Technical Service Bulletin

NUMBER: 08-001-02

Rear Window Defogger Inoperative

Fig. 3 CLIP ORIENTATION AND ATTACHMENT

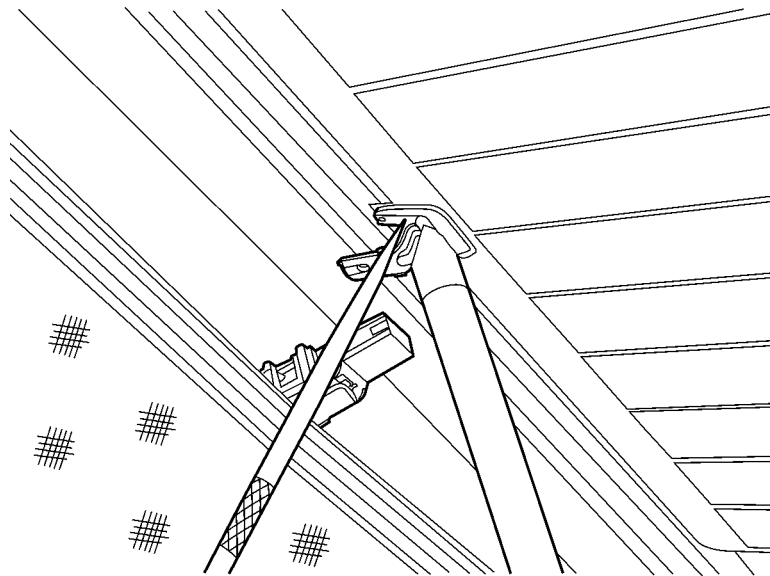
6. Holding the new terminal clip with a metal “pick” or other suitable pointed tool, place the new terminal clip in the same location as the original terminal clip but with the tip of clip facing outboard.

NOTE: THE TIP OF THE TERMINAL CLIP MUST FACE OUTBOARD. CLIPS ARE PRE-SOLDERED AND FLUXED. DO NOT REUSE A CLIP IF IT HAS BEEN HEATED PREVIOUSLY.

7. Place the solder gun on the new terminal clip and heat until the solder flows. Remove the solder gun and continue to hold the clip in position for 5 seconds. Let the solder area cool for 10 minutes, (Fig. 3).
